## Response matrix to Willoughby Council RFI of 30 Sep 2021

## Appendix 1 – Overshadowing Analysis

Figure 14 – Sun eye view corresponding with Fig 13. Note the extent of the rear yards visible in the diagram corresponds with the sunlit portions of the rear yards of the houses in The Postern.

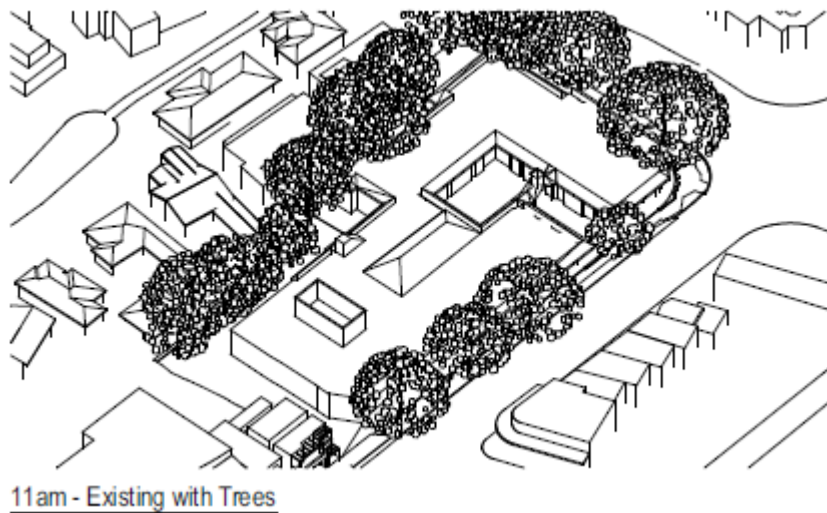
A similarly comparative aerial photo for approximately 11am at the equinox is below together with a sun eye view of the corresponding time.
